Access Compliance Report

Public Rights-of-Way

(Curb Ramps)

Intersection ID: 10027660	Main Street: GREENWOOD_CLIFF	Cross Street: N/A	Location: NW
ADA ID: 9AEE8B4488D7	Ramp Type: Perp	Initial Pass/Fail: Pass	Overall Compliance: No
Severity Score: 0.25			
Codes/Mitigation Info/Possible Solution		Field Measurements/Component Compliance

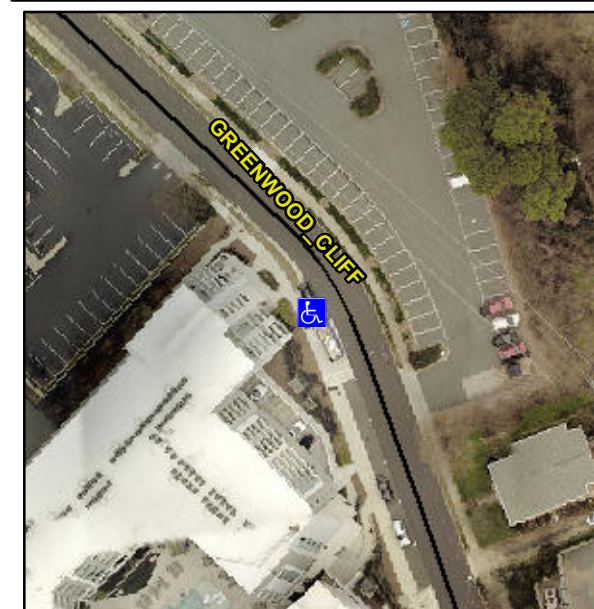
Not Found, R304.5.3, R304.2.1, R304.2.2-Perp, R304.3.2-Para, R305.2

Compliance	Description	Data	Compliance	Description	Data
N/A	Ramp Length (in)	48.0	Yes	Ramp Slope (%)	5.6
Yes	Ramp Width (in)	71.0	No	Ramp XSlope (%)	2.7
Yes	Flare Type L	Curbed_NoWalkSurface	N/A	Flare Type RT	N/A
Yes	Flare Slope LT (%)	N/A	N/A	Flare Slope RT (%)	N/A
N/A	Flare Traversable LT?	No	N/A	Flare Traversable RT?	N/A
No	Landing Length (in)	46.5	Yes	DWS Provided?	Yes
Yes	Landing Width (in)	71.0	Yes	DWS Contrast?	Yes
No	Landing Slope (%)	2.3	Yes	DWS Length (in)	24.0
Yes	Landing X Slope (%)	0.1	Yes	DWS Full Width?	Yes
N/A	Landing Curb? (Y/N)	No	No	DWS Offset (in)	6.0
N/A	Shared Landing?	No			
Yes	Gutter Ponding?	No	Yes	Gutter Slope (%)	0.8
Yes	Gutter Lip Ht (in)	0.0	Yes	Gutter X Slope (%)	1.7
N/A	Painted X Walk1?	No	N/A	Painted X Walk2?	N/A
	X Walk 1 Direction	To SW		X Walk 2 Direction	N/A
N/A	X Walk 1 Width (in)	N/A	N/A	X Walk 2 Width (in)	N/A
	X Walk 1 Slope (%)	1.9		X Walk 2 Slope (%)	N/A
	X Walk 1 X Slope (%)	1.9		X Walk 2 X Slope (%)	N/A

Remove & Replace Entire Ramp.
